TECHNICAL IMPROVEMENT  
No-SC/CV/TI/14-15\_390  
Dt.-29.01.2015

SUB GROUP: DSL FL  
Model : Maxima

**IMPROVEMENT: MODIFIED PINION DIFFERENTIAL-MAXIMA DSL**

**Pinion differential damper**

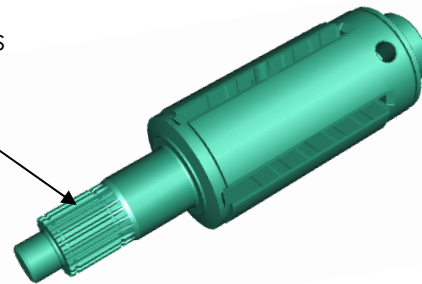
**Reason for Change:** to address field issue of 'failure of differential pinion.'

Spline fillet radius and tip chamfer added to increase strength of pinion & mainshaft.

Modified at splines

**Part Details:** Serviceable part nos remains same & are interchangeable

- 1) BB133098 -pinion differential damper
- 2) BB133061-shaft main Assly
